**STAFF RECOMMENDATION**  
**1809 Cedar Lane**  
**October 21, 2015**

**Application:** New construction - addition  
**District:** Belmont-Hillsboro Neighborhood Conservation Zoning Overlay  
**Council District:** 18  
**Map and Parcel Number:** 11704032300  
**Applicant:** Nick Dryden, Architect  
**Project Lead:** Sean Alexander, sean.alexander@nashville.gov

<p><b>Description of Project:</b> The applicant proposes to enlarge a contributing house with a ridge raise and rear addition.</p> <p><b>Recommendation Summary:</b> Staff recommends approval of the proposed addition with the condition that staff approves the roof color, masonry, and the selections of windows and doors. Meeting that condition, Staff finds the proposal to meet the design guidelines for additions in the Belmont-Hillsboro Neighborhood Conservation Zoning Overlay.</p>	<p><b>Attachments</b> <b>A:</b> Photographs <b>B:</b> Site Plan <b>D:</b> Elevations</p>
--	--

**1 FIRST FLOOR DEMOLITION PLAN**

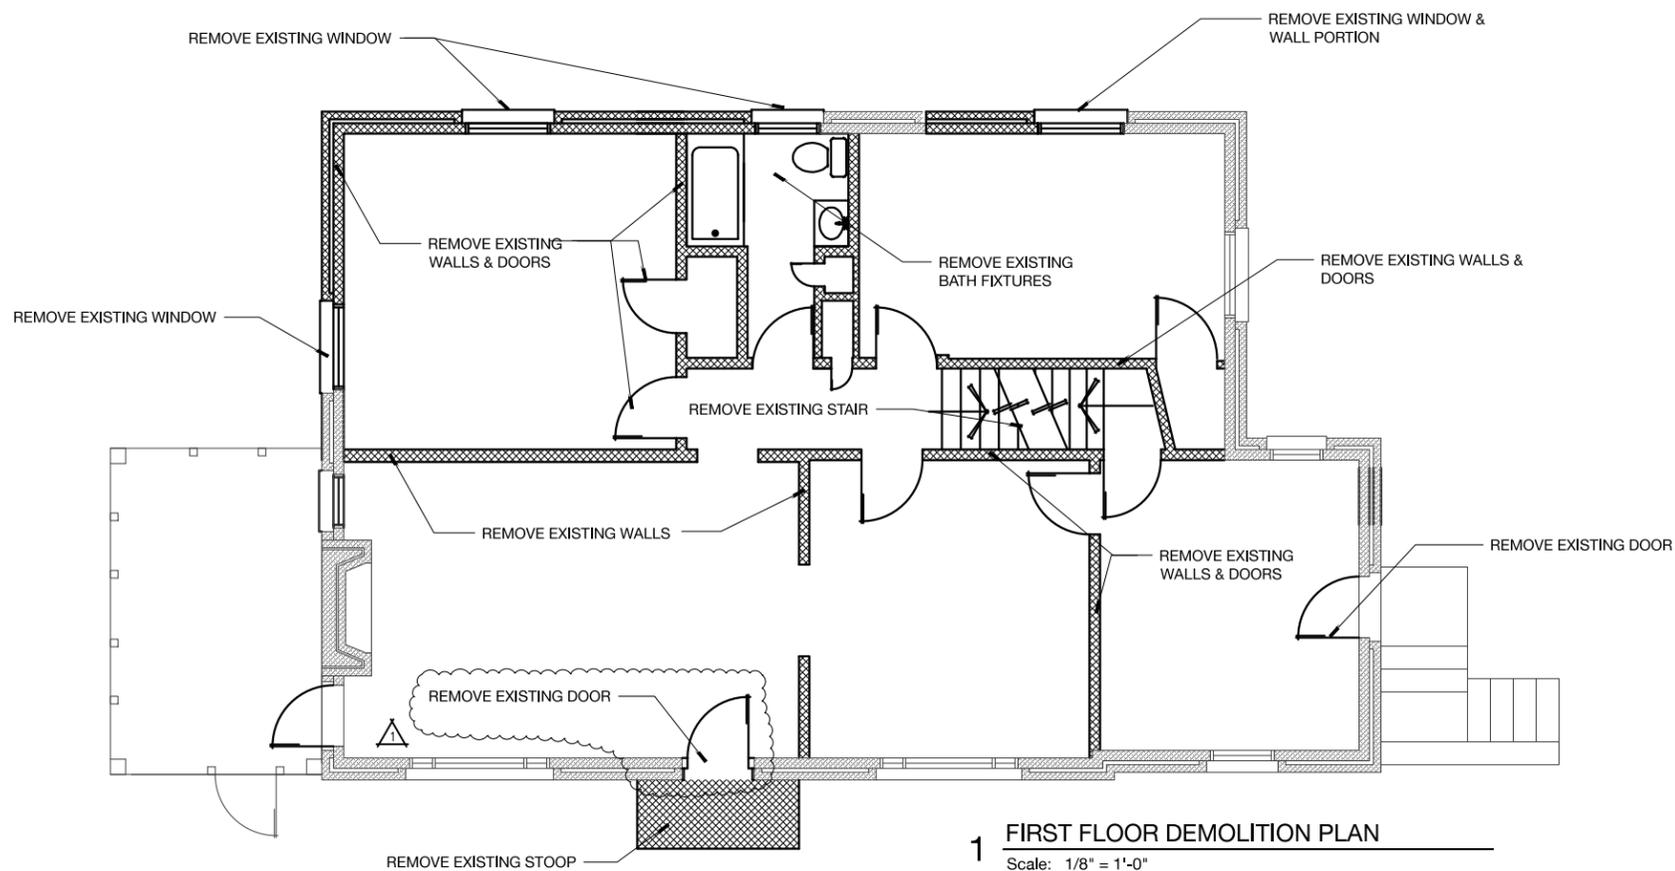
The proposal includes a side addition, requiring the partial demolition of the left side wall of the building, along with a window on the left wall. Alteration of a side elevation is generally not appropriate, however on lots wider than sixty feet (60') the design guidelines allow side additions. The lot at 1809 Cedar Lane is one hundred feet (100') wide. Meeting the criteria for side additions, Staff finds the partial demolition on the left side of the building to meet guideline V.2.b.

1 BASEMENT FLOOR PLAN  
 Scale: 1/8" = 1'-0"

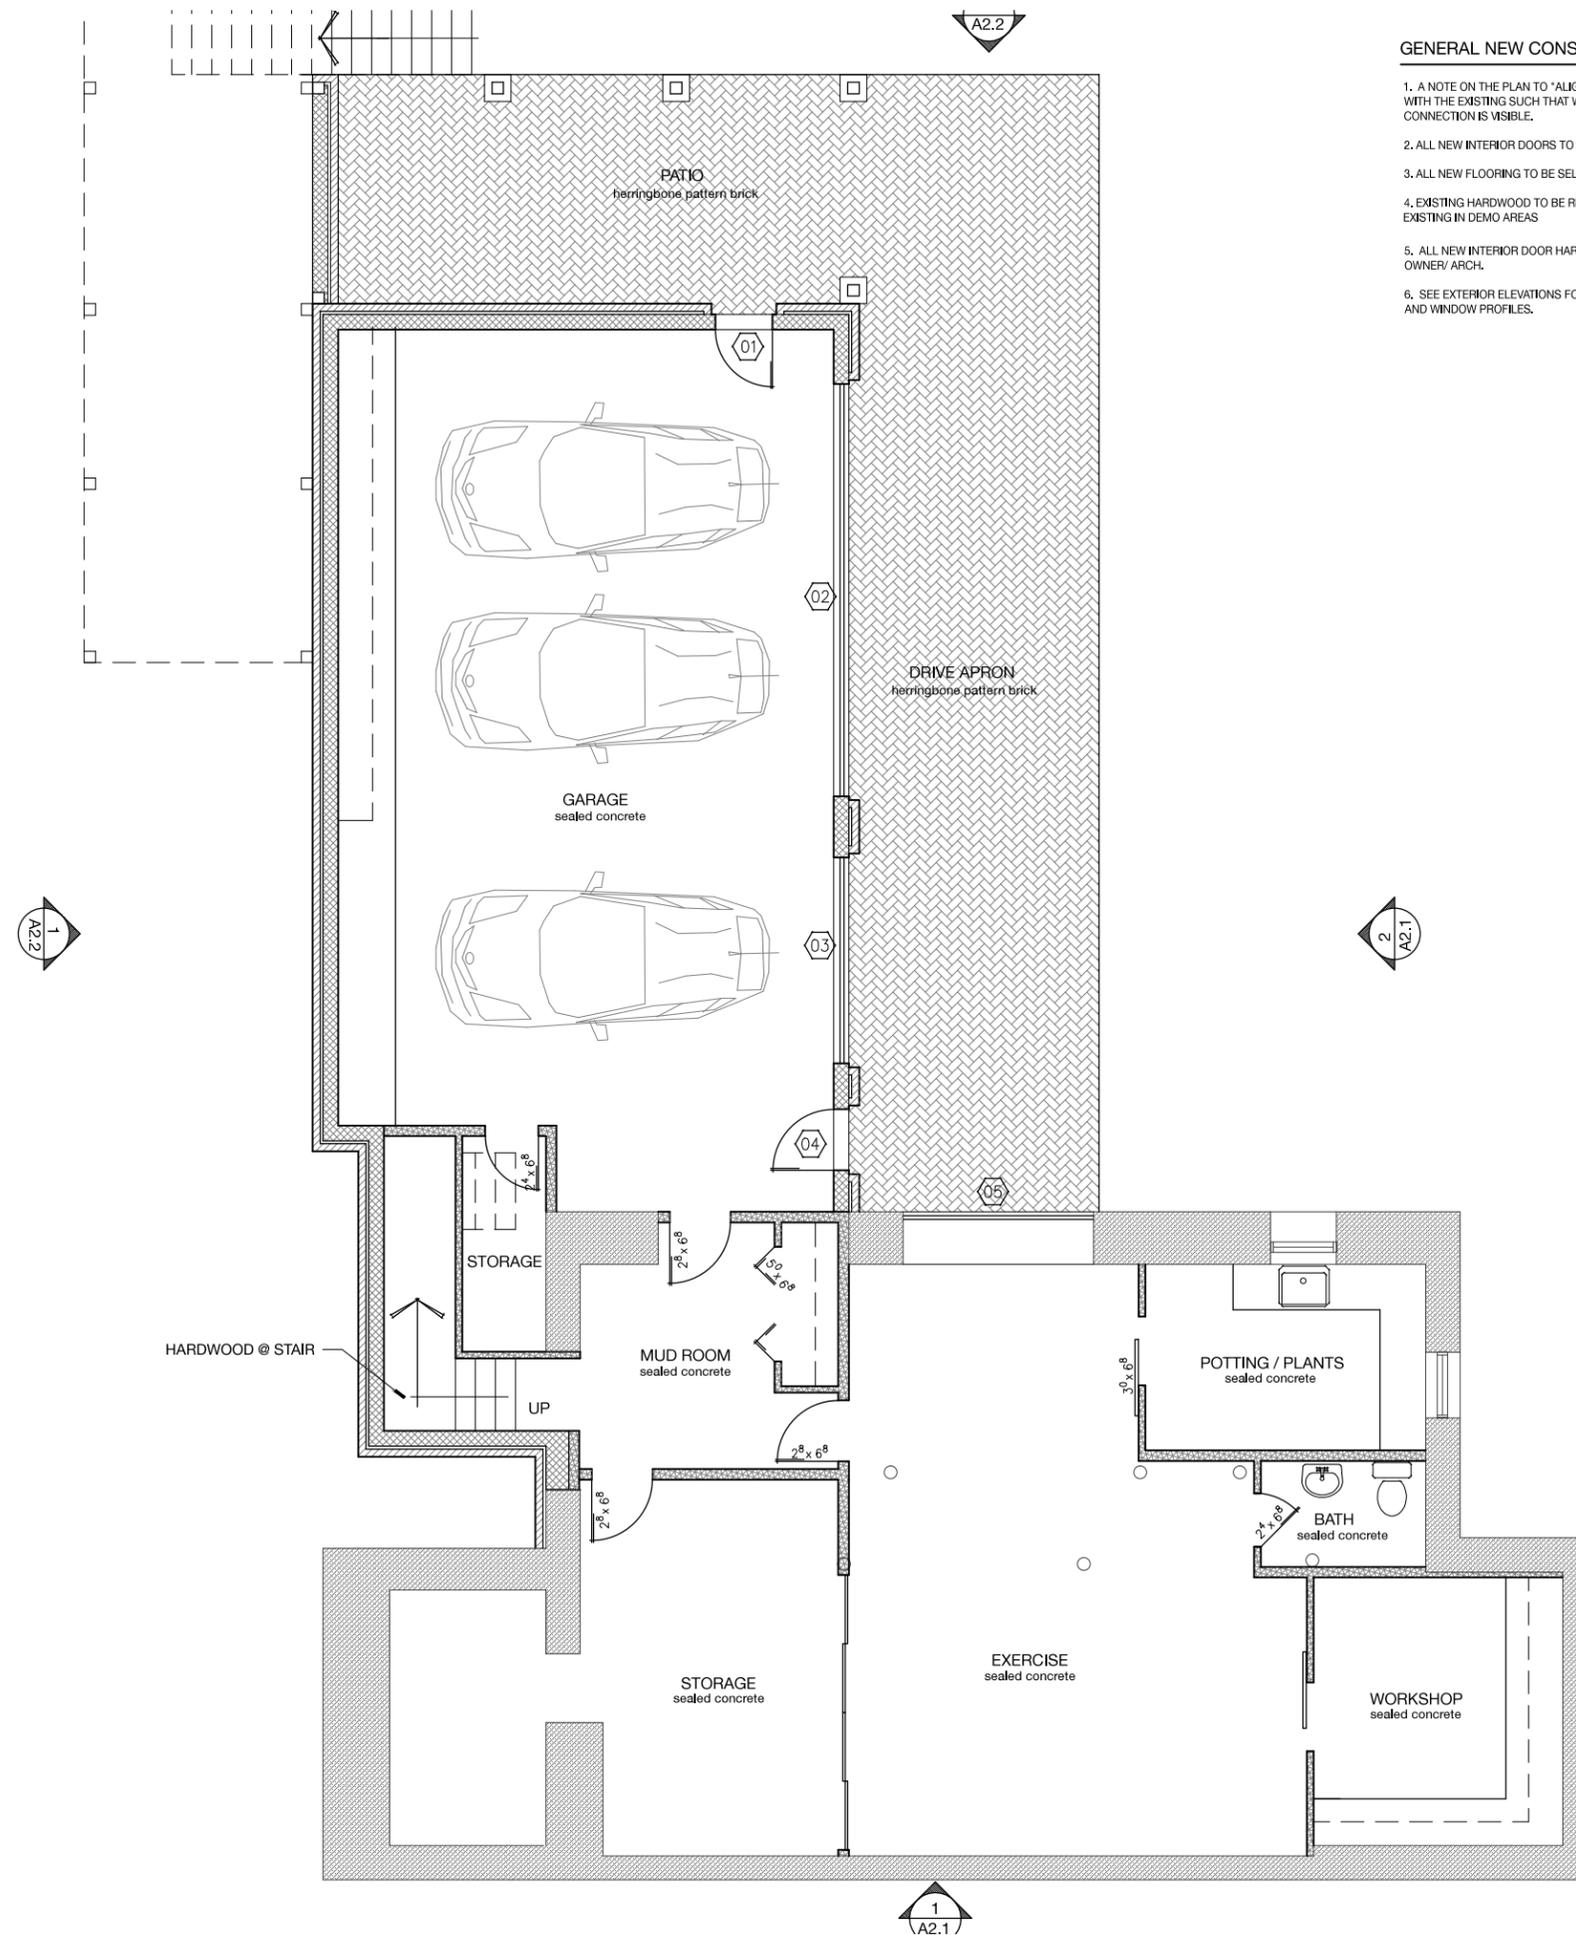
The proposal includes a three-bay garage in the basement level, accessed from the existing driveway on the right side of the house. This garage location is appropriate because it is in the location of an existing garage. Staff finds that the project meets section II.B.1.i of the design guidelines.

**1 FIRST FLOOR PLAN**  
Scale: 1/8" = 1'-0"

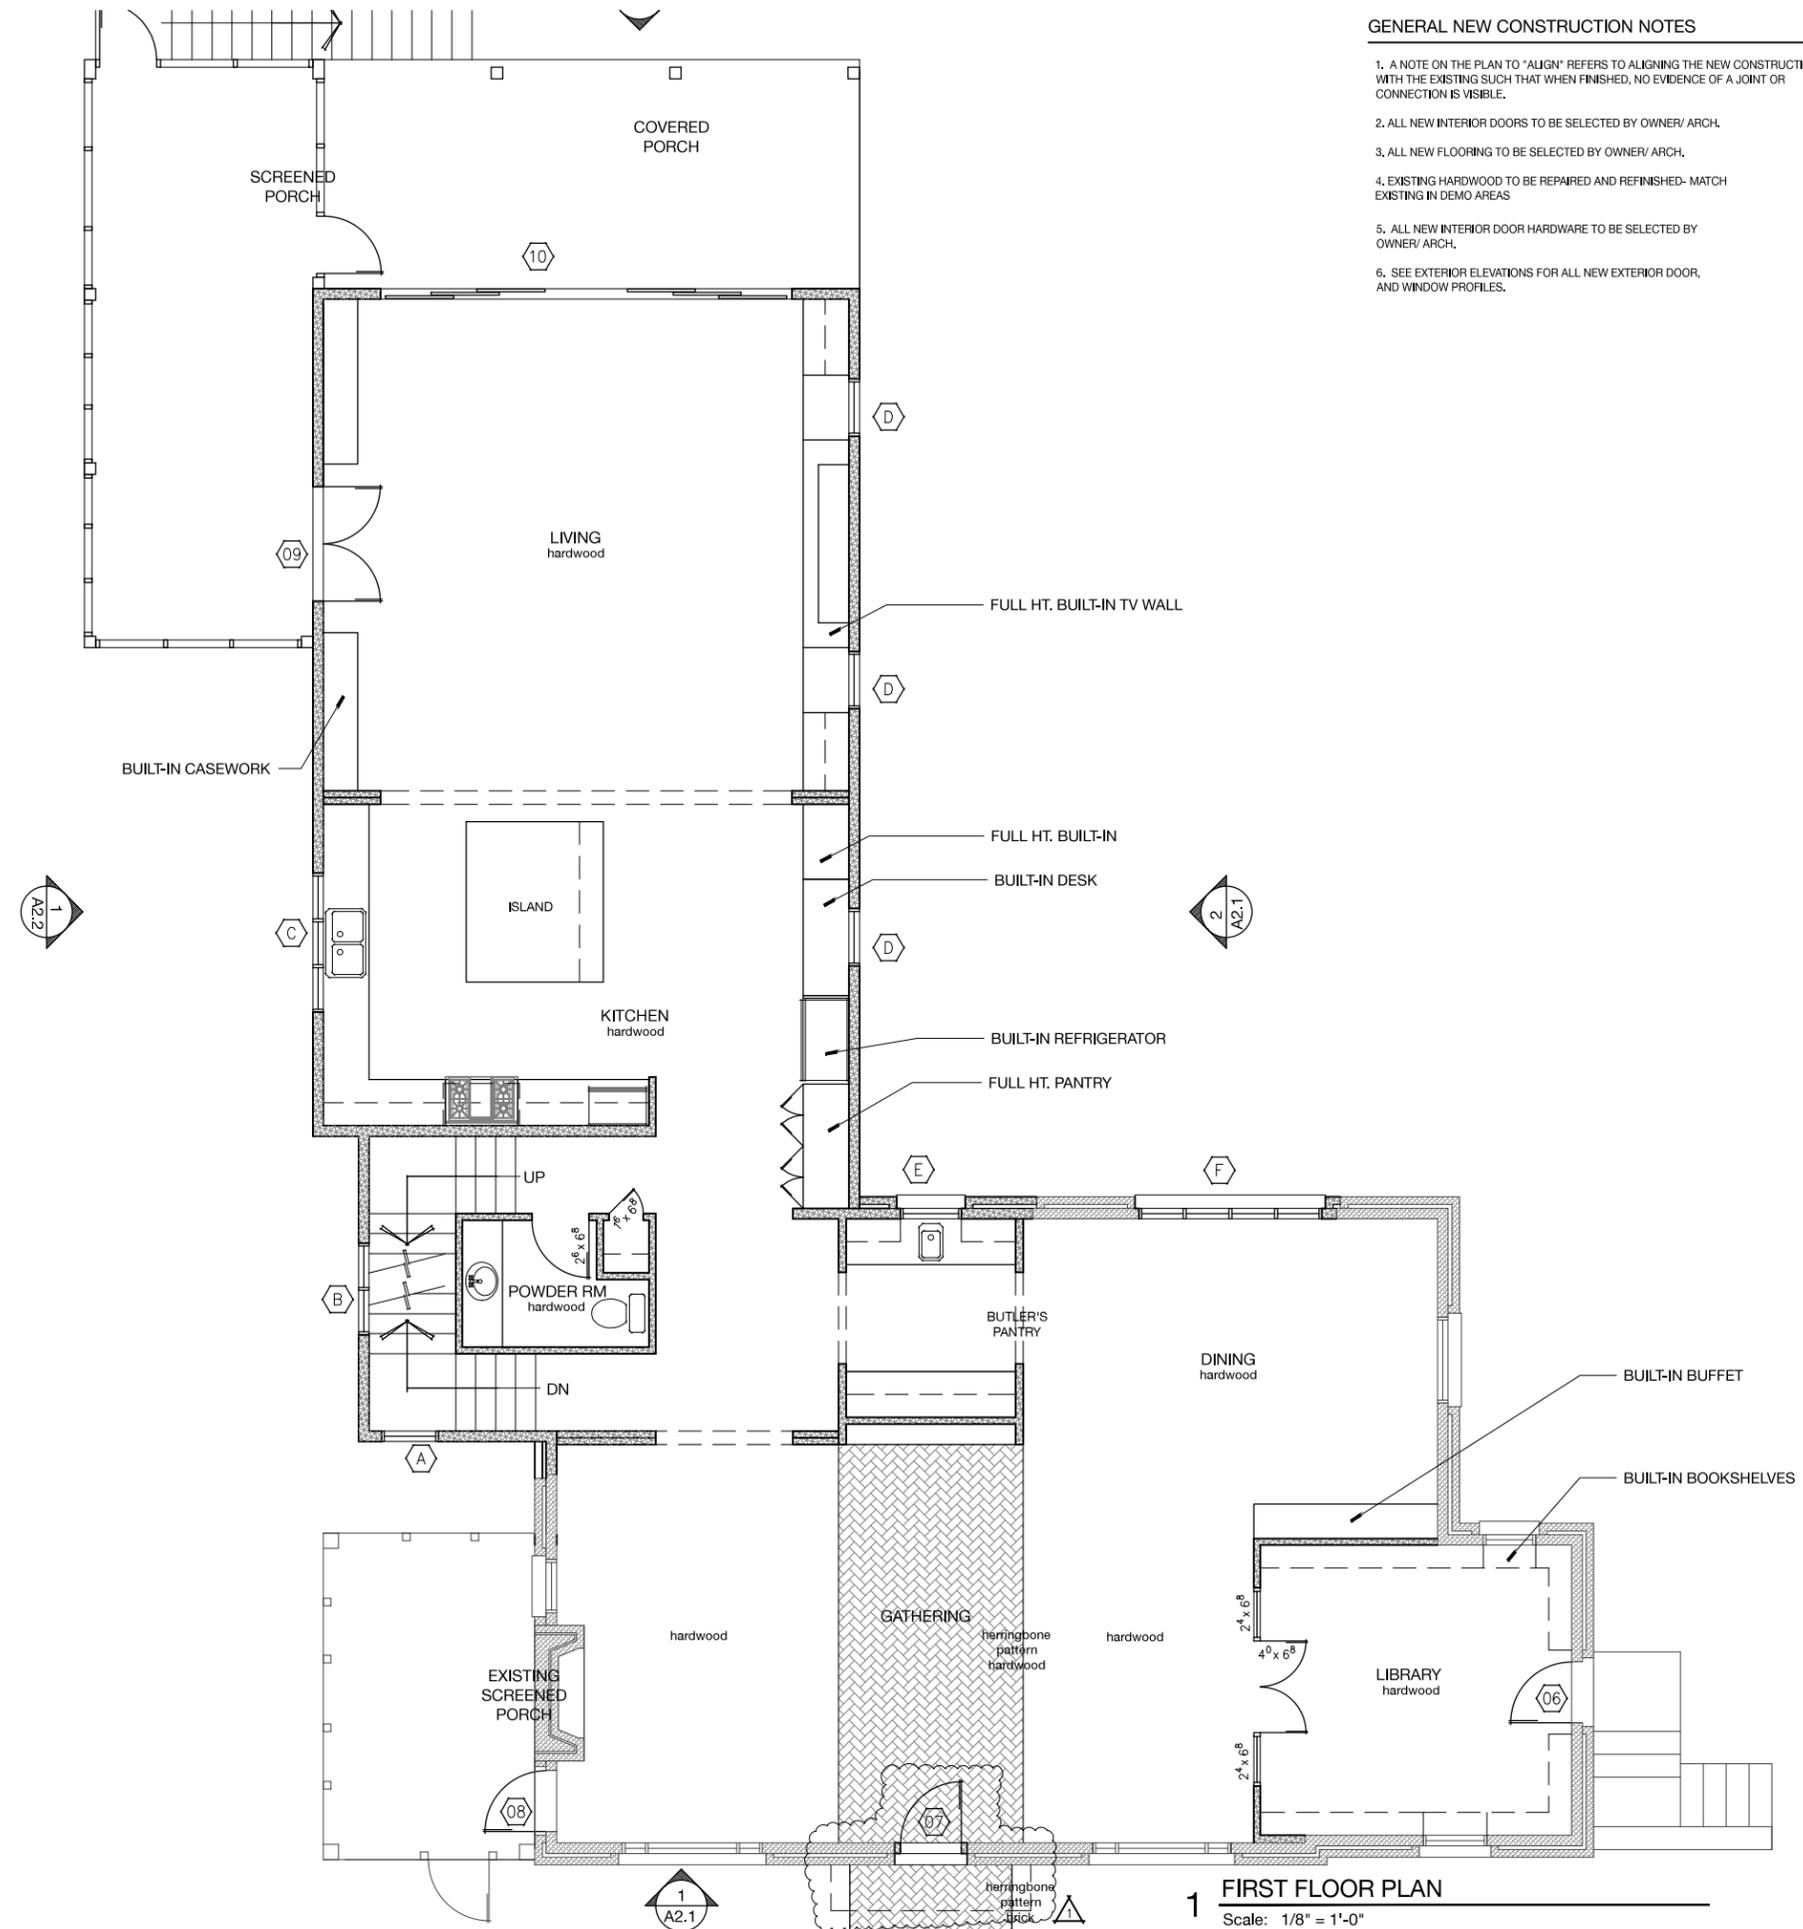
On the first story, the addition will originate on the left wall eighteen feet (18') back from the front edge of the building, behind an existing side porch. Side additions are generally not appropriate except on houses that are unusually narrow, shifted to one side of the lot, or on a lot that is wider than the typical lots nearby. This lot is one hundred feet (100') wide, whereas lots nearby typically range between seventy feet (70') and ninety feet (90'). The addition will sit in twenty-six feet (26') from the right side of the historic house, obscuring it from visibility from the right-of-way to that side.

Originating behind the midpoint of the house on the left side, the addition will step out eight feet (8'), extend back thirteen feet (13'), and step out again an additional two feet (2') to the left. The addition will then extend back thirty-seven feet (37') for a total depth of fifty feet (50') to the rear.
